COMMITTEE OF THE WHOLE APRIL 22, 2002

**DRAFT PLAN OF SUBDIVISION FILE 19T-01V03
ZONING BY-LAW AMENDMENT FILE Z.01.013
MIDVALE ESTATES LIMITED
REPORT#P.2001.24**

<p>ATTACHMENT '5' REVISED DRAFT PLAN</p>	FILE #:	REPORT #:	DATE: 01/16/2002
	Z.01.013 19T-01V03	LOCATION: PART OF LOT 16, CON. 8	APPLICANT: MIDVALE ESTATES LIMITED
CITY OF VAUGHAN PLANNING DEPARTMENT		SCALE: NOT TO SCALE

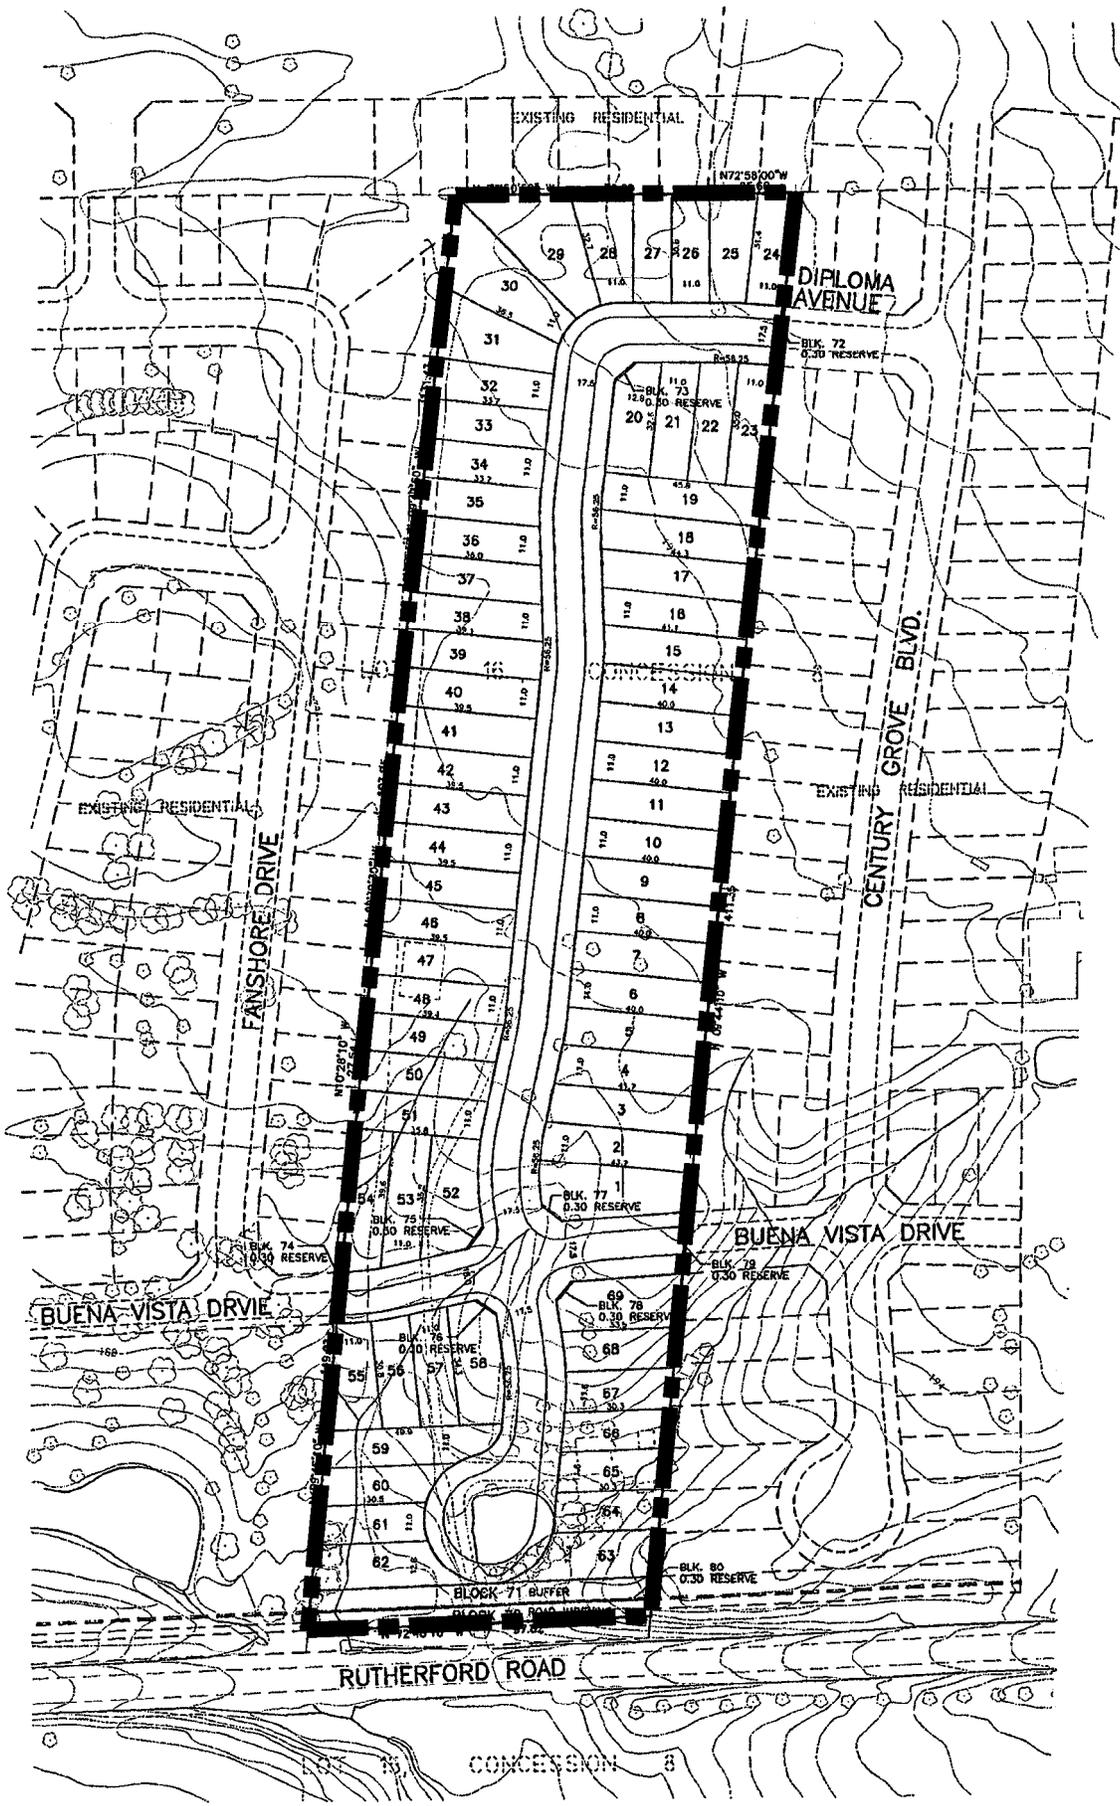
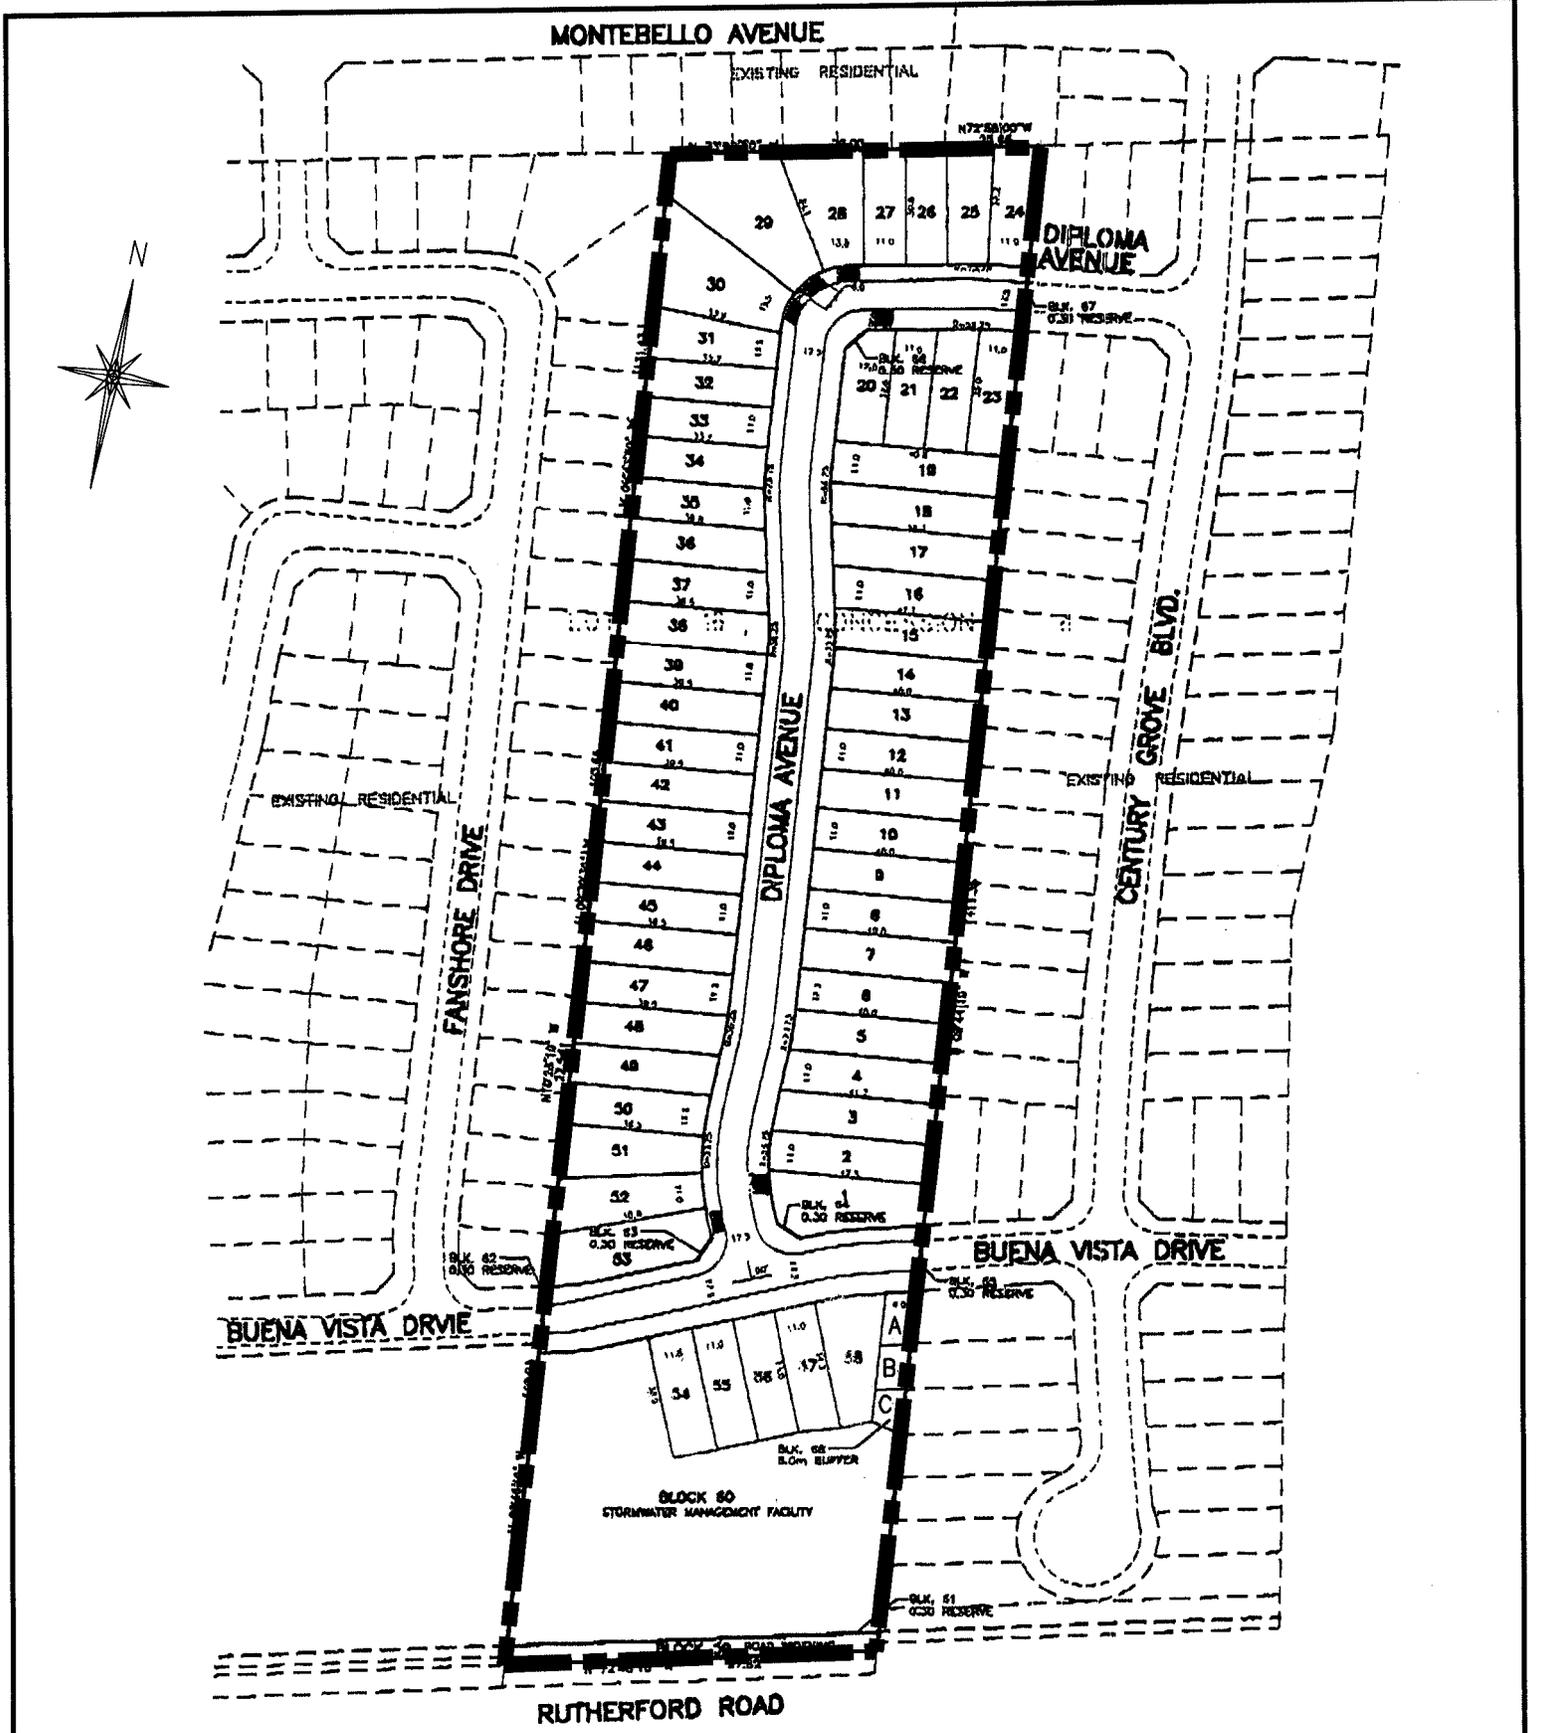
On January 15, 2002, the applicant submitted a revised Draft Plan of Subdivision to replace the 15 lots at the south with a stormwater management and 5 lots. To date, the revised plan includes 58 residential lots and a stormwater pond.

The most recent revision provides an 8m buffer between the southerly 5 lots and the 3 existing lots to the east, as an extension to the stormwater pond block. Staff have concerns regarding the ongoing maintenance of this block and have red-lined this plan to subdivide the buffer strip into 3 blocks. A condition of approval requires that these blocks be transferred to either the City or the abutting 3 lots to the east, and be landscaped and zoned OS1 Open Space Conservation Zone. Prior to registration of the plan, it will be determined if the blocks will be conveyed to private ownership for maintenance purposes.

RED-LINE PLAN - APRIL 22, 2002
